# AASCO

Thank you for purchasing AASCO precision performance valve springs. To insure proper performance and life from your springs the following change needs to be made to the bottom spring retainer (spring seat Porsche # 901.105.463.00).

AASCO Inner Spring

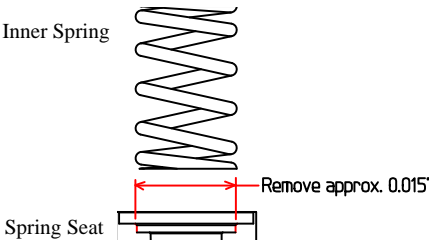
Remove approx. 0.015" (.38mm) from the seat in the area shown so the inner spring sits freely in the seat.

Installed height: 1.350" (34mm).

993 applications with 8mm valves: the valve spring retainer must be replaced with our Titanium retainers (P.N. HP10T8) and the spring seat with P.N. HPSS and machined as illustrated above.
